SERVICE LETTER

SUBJECT: VICKERS SERVICE LETTERS 29-920422-01 & 29-933322-01 AND SERVICE BULLETINS 920422-29-02, 920422-29-03, 933322-29-01, 920422-01-29 AND 933322-29-02 - ELECTRIC MOTOR-DRIVEN HYDRAULIC PUMP ASSEMBLY.

Date: December 16/97

Find The Position Of The DPI Sensing Port
Figure 1

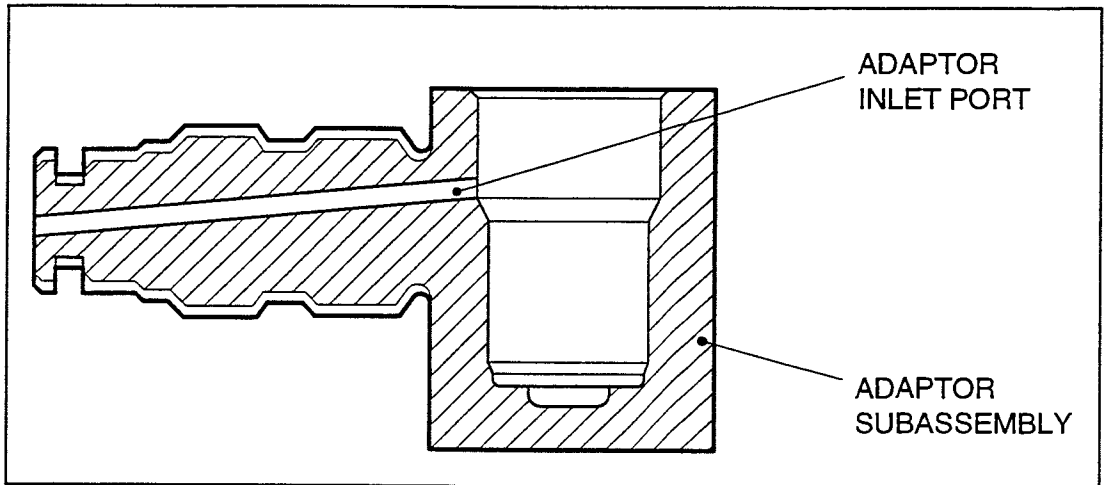
NOTE: You cannot see the DPI sensing port on the external surface of the DPI because of the filter screen. You must look for it from inside the magnet housing recess.
 - C. Refer to Figure 2 of this Service Letter. With the help of an additional light source, find the position of the adaptor inlet port. Record this position.
 - D. With the help of the temporary mark you made in step 1.A, compare the position of the DPI sensing port with the position of the adaptor inlet port when the DPI was installed in the adaptor subassembly. If the position of the DPI sensing port is found not to be diametrically opposite (180°) the adaptor inlet port, assemble the DPI as specified in the steps that follow. If the position of the DPI sensing port is found to be diametrically opposite (180°) the adaptor inlet port, embody Modification No 1 as specified in Service Bulletin 920422-29-02.

- A. Install the magnet, the magnet housing and the spring on the body of the DPI.
- B. Install DPI (110) together with its spring in adaptor subassembly (140). Make sure that the DPI is installed with its sensing port diametrically opposite (180°) the adaptor inlet port.
- C. Install four screws (115) and washers (120) in the flange of DPI (110) and attach the DPI to adaptor subassembly (140).
- D. Torque four screws (115) equally and symmetrically in a diagonally opposite sequence to between 1,81 and 2,26 Nm (16,0 and 20 lbf in).
- E. Remove the temporary mark that you made in step 1.A.

Find The Position Of The DPI Sensing Port
Figure 1

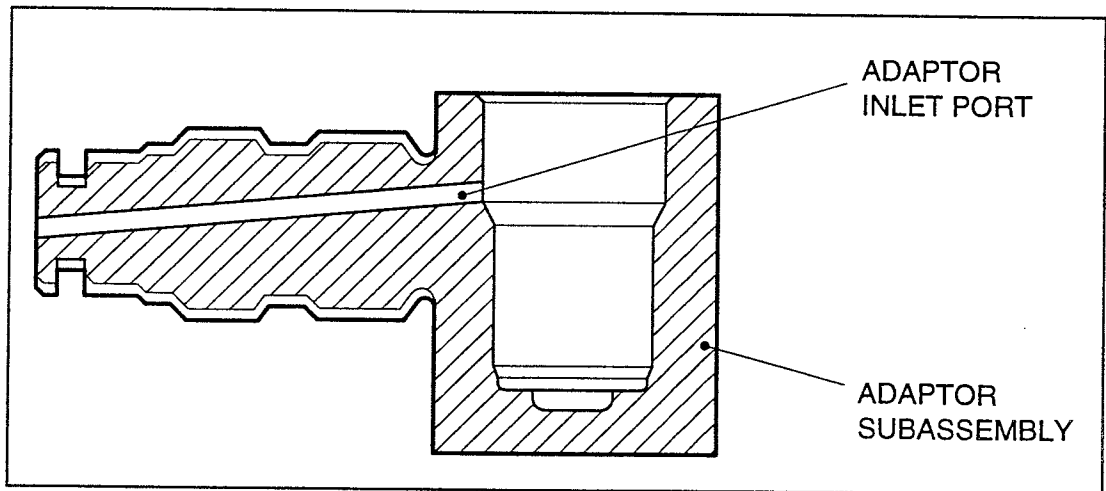
NOTE: You cannot see the DPI sensing port on the external surface of the DPI because of the filter screen. You must look for it from inside the magnet housing recess.
 - C. Refer to Figure 2 of this Service Letter. With the help of an additional light source, find the position of the adaptor inlet port. Record this position.
 - D. With the help of the temporary mark you made in step 1.A, compare the position of the DPI sensing port with the position of the adaptor inlet port when the DPI was installed in the adaptor subassembly. If the position of the DPI sensing port is found not to be diametrically opposite (180°) the adaptor inlet port, assemble the DPI as specified in the steps that follow. If the position of the DPI sensing port is found to be diametrically opposite (180°) the adaptor inlet port, embody Modification No 1 as specified in Service Bulletin 933322-29-01.

- A. Install the magnet, the magnet housing and the spring on the body of the DPI.
- B. Install DPI (155) together with its spring in adaptor subassembly (185). Make sure that the DPI is installed with its sensing port diametrically opposite (180°) the adaptor inlet port.
- C. Install four screws (160) and washers (165) in the flange of DPI (155) and attach the DPI to adaptor subassembly (185).
- D. Torque four screws (160) equally and symmetrically in a diagonally opposite sequence to between 1,81 and 2,26 Nm (16,0 and 20 lbf in).
- E. Remove the temporary mark that you made in step 1.A.

Find The Position Of The Adaptor Inlet Port
Figure 1

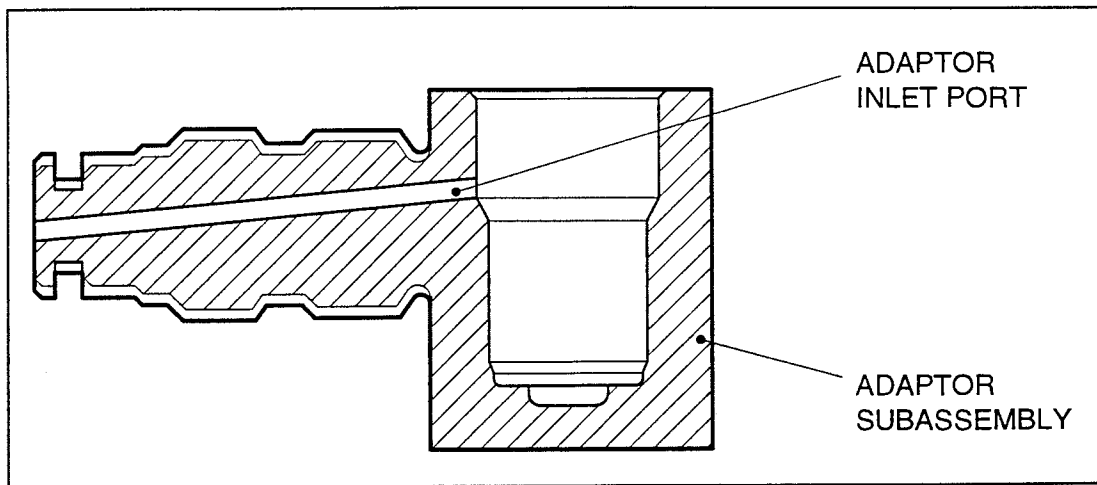
This Service Bulletin is a product improvement. It replaces the DPI together with the related filter by-pass valve. Internal changes to the new DPI make it less sensitive to high pressure spikes and mechanical shocks.

Because it is also necessary for the DPI sensing port to be diametrically opposite (180°) the inlet port of the adaptor subassembly, the new DPI has a location hole in its flange. Because the hole is related to the position of the DPI sensing port, it helps you install the DPI in the correct position in relation to the adaptor subassembly.

- (4) Refer to the reference Component Maintenance Manual 29-10-45. Install new packings (Part Number M83248-1-014 and M83248-1-015) and back-up ring (Part Number MS28774-015) in the related packing grooves of the new DPI, Part Number QA07881, in the positions shown.
- (5) Install the new DPI, Part Number QA07881, together with its spring in adaptor subassembly (140). Make sure that the location hole in the flange of the new DPI is diametrically opposite (180°) the mark that you made on the adaptor subassembly in step 3.A(5) .
- (6) Install four screws (115) and washers (120) in the flange of the new DPI and attach the DPI to adaptor subassembly (140).
- (7) Torque four screws (115) equally and symmetrically in a diagonally opposite sequence to between 1,81 and 2,26 Nm (16,0 and 20 lbf in).
- (8) Remove the temporary mark that you made on the adaptor subassembly in step 3.A(5).

Position of the Locating Pin Hole
Figure 1

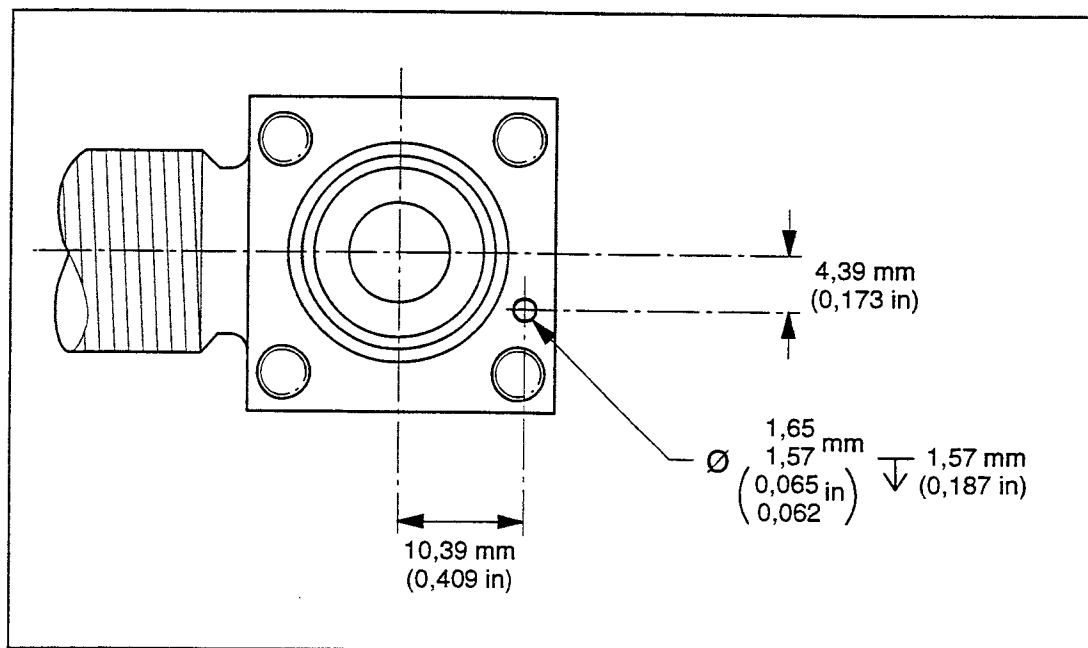
This Service Bulletin is a product improvement which installs a locating pin in the adaptor subassembly. The locating pin will engage the location hole in the flange of the DPI installed by Vickers Systems Service Bulletin 920422-29-02 (Mod 1). Thus the DPI will always be installed in the correct position in relation to the adaptor subassembly.

- (1) Refer to Figure 1 of this Service Bulletin. Make a hole in the top face of the adaptor subassembly with a 1,65/1,57 mm (0,065/0,062) drill to a depth of 1,57 mm (0,187 in) in the position shown.

- (2) Deburr the hole. Remove all unwanted material from the hole and the adaptor subassembly.
- (3) Apply Alocrom 1200, or equivalent, to the hole as specified in the reference Component Maintenance Manual 29-10-45.
- (4) Install pin, Part Number 215723, in the related hole in the top face of the adaptor subassembly. Push the pin fully in the hole.

Find The Position Of The Adaptor Inlet Port
Figure 1

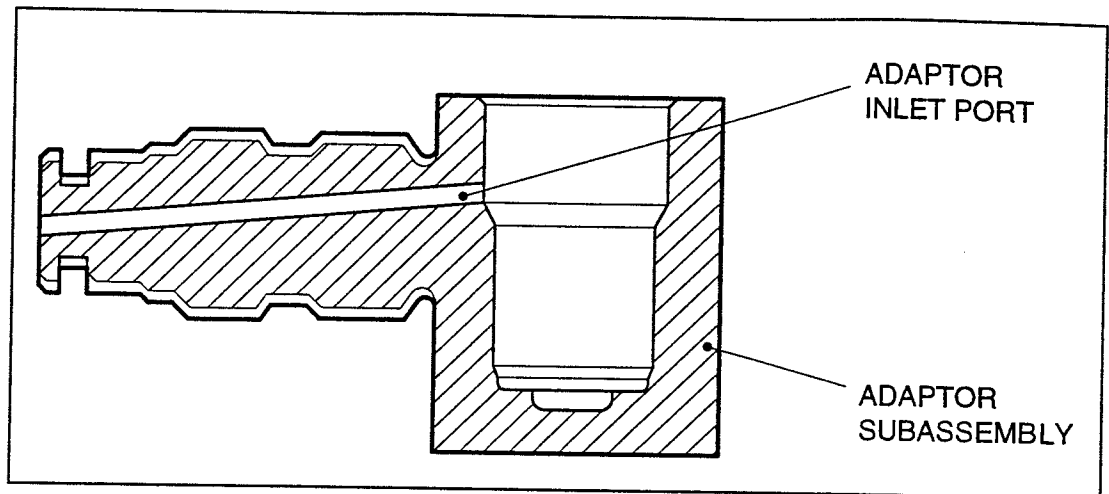
This Service Bulletin is a product improvement. It replaces the DPI together with the related filter by-pass valve. Internal changes to the new DPI make it less sensitive to high pressure spikes and mechanical shocks.

Because it is also necessary for the DPI sensing port to be diametrically opposite (180°) the inlet port of the adaptor subassembly, the new DPI has a location hole in its flange. Because the hole is related to the position of the DPI sensing port, it helps you install the DPI in the correct position in relation to the adaptor subassembly.

- (4) Refer to the reference Component Maintenance Manual 29-10-47. Install new packings (Part Number M83248-1-014 and M83248-1-015) and back-up ring (Part Number MS28774-015) in the related packing grooves of the new DPI, Part Number QA07881, in the positions shown.
- (5) Install the new DPI, Part Number QA07881, together with its spring in adaptor subassembly (185). Make sure that the location hole in the flange of the new DPI is diametrically opposite (180°) the mark that you made on the adaptor subassembly in step 3.A(5) .
- (6) Install four screws (160) and washers (165) in the flange of the new DPI and attach the DPI to adaptor subassembly (185).
- (7) Torque four screws (160) equally and symmetrically in a diagonally opposite sequence to between 1,81 and 2,26 Nm (16 and 20 lbf in).
- (8) Remove the temporary mark that you made on the adaptor subassembly in step 3.A(5).

Position of the Locating Pin Hole
Figure 1

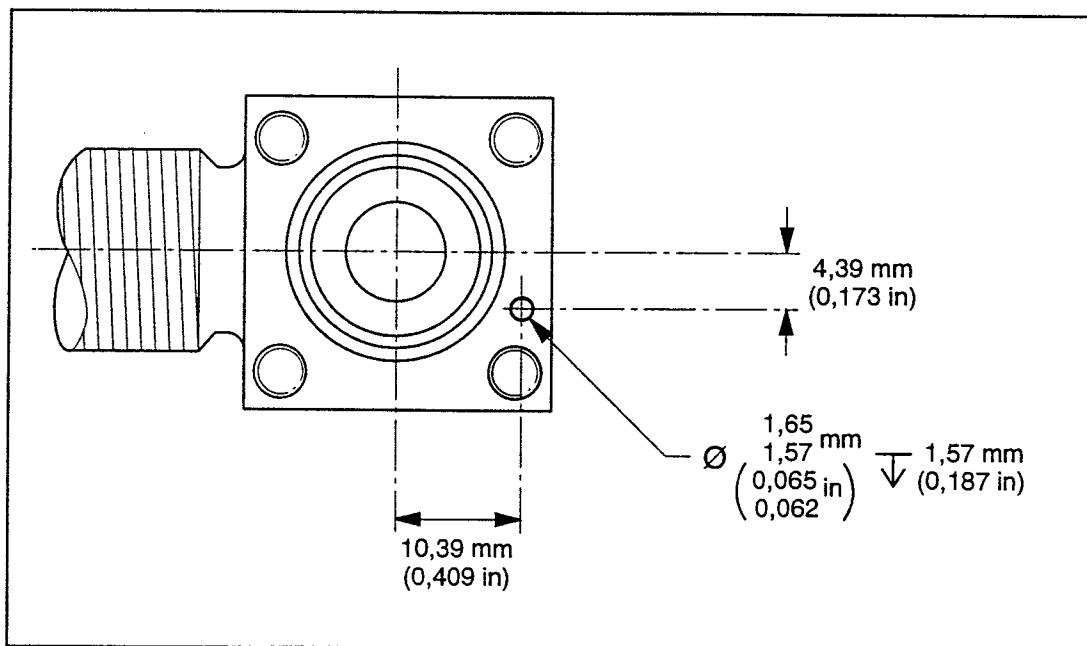
This Service Bulletin is a product improvement which installs a locating pin in the adaptor subassembly. The locating pin will engage the location hole in the flange of the DPI installed by Vickers Systems Service Bulletin 933322-29-01 (Mod 1). Thus the DPI will always be installed in the correct position in relation to the adaptor subassembly.

- (1) Refer to Figure 1 of this Service Bulletin. Make a hole in the top face of the adaptor subassembly with a 1,65/1,57 mm (0,065/0,062 in) drill to a depth of 1,57 mm (0,187 in) in the position shown.

- (2) Deburr the hole. Remove all unwanted material from the hole and the adaptor subassembly.
- (3) Apply Alocrom 1200, or equivalent, to the hole as specified in the reference Component Maintenance Manual 29-10-47.
- (4) Install pin, Part Number 215723, in the related hole in the top face of the adaptor subassembly. Push the pin fully in the hole.
